LAKE PONTCHARTRAIN, LA. AND VICINITY  
 LAKE PONTCHARTRAIN BARRIER PLAN

DESIGN MEMORANDUM NO. 2 - GENERAL  
 SUPPLEMENT NO. 8  
 INNER HARBOR NAVIGATION CANAL REMAINING LEVEES

COMMENTS ON SUPPLEMENT NO. 8 GDM NO. 2, IHNC, REMAINING LEVEES,  
LAKE PONTCHARTRAIN BARRIER PLAN.

PLATE IV-8

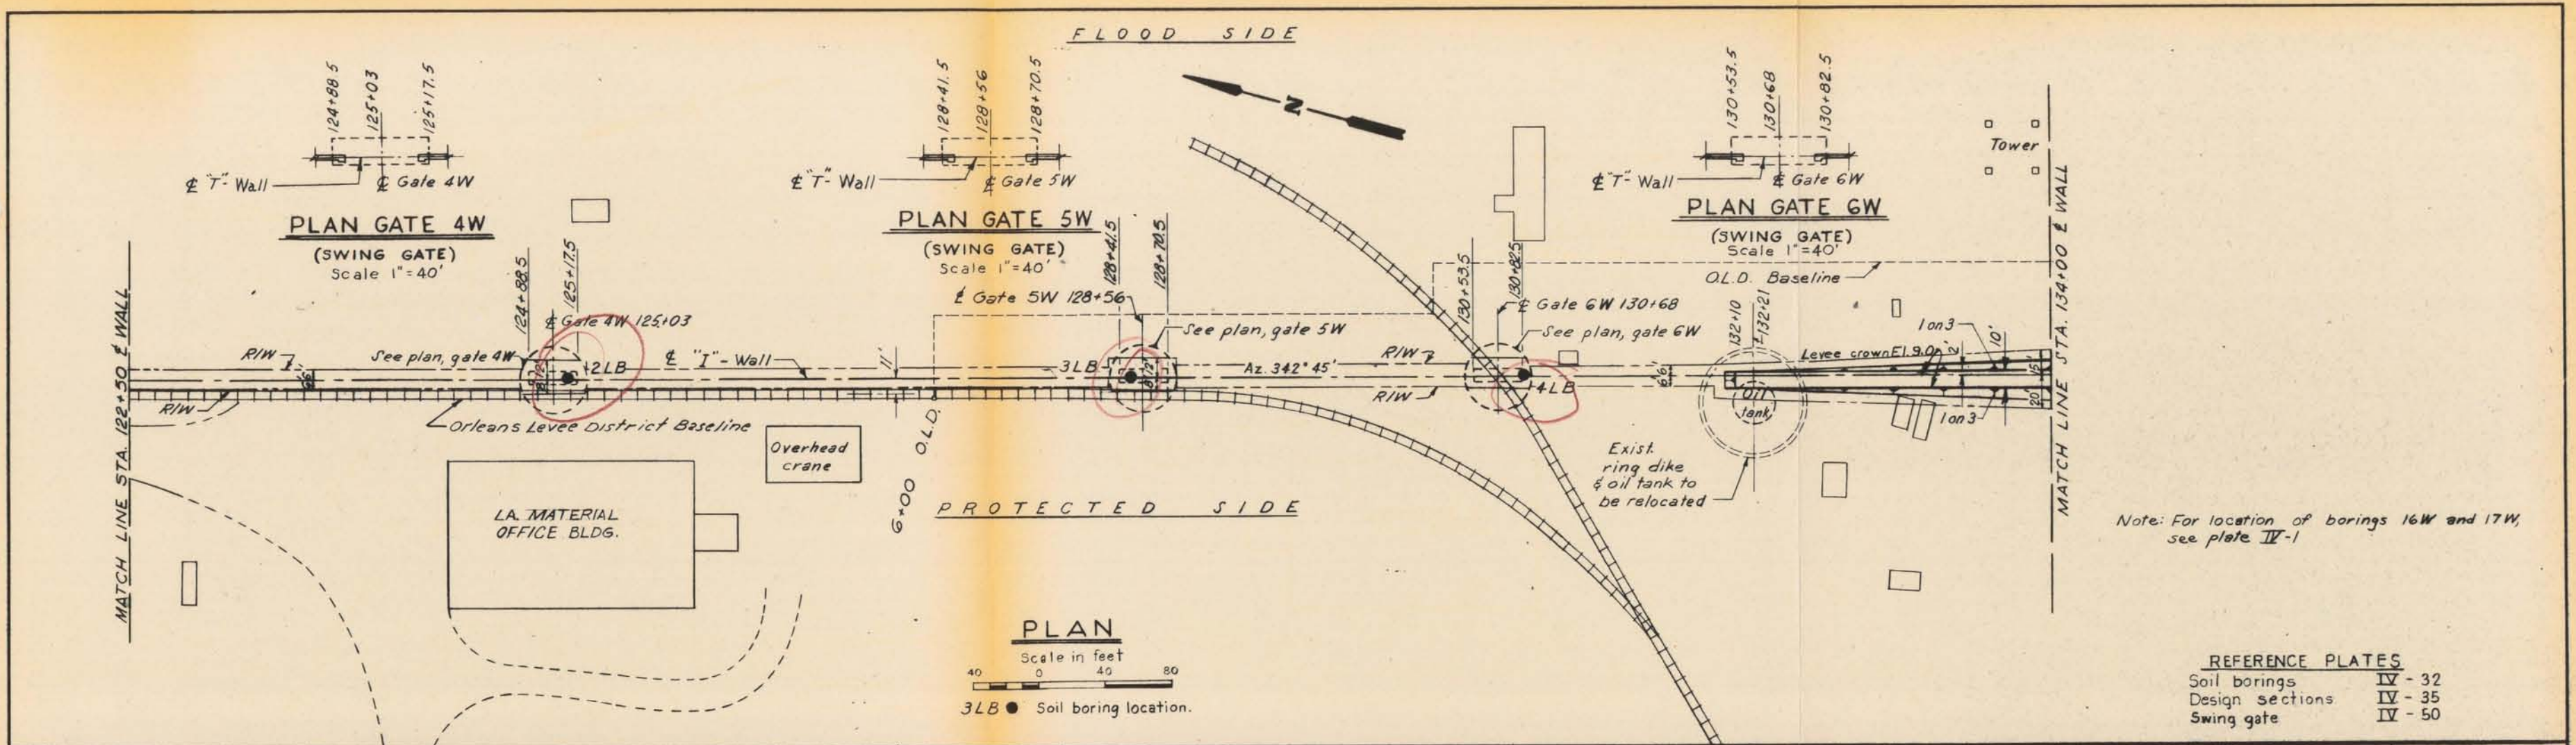
13. Plate IV-8. The profile indicates the embankment grade at highway 90 to be at least 2 feet above the wall. This suggests that the wall alignment need not be offset as far as indicated on the plan to reach an embankment level adequate for the wall connection, and that a reduction in the length of the wall at both sides of the embankment is possible.

5. Para 1a(14). This comment is not clear. It is possible that the original comment was not understood. As shown on Plate IV-8, the wall is turned 90 degrees at each side of the bridge abutment to tie into the fill at the end of the bridge. The grade of the highway embankment is about 2 feet above the top of the wall, indicating that the wall could connect with the highway embankment landward of the end of the bridge rather than at the end of the bridge abutment.
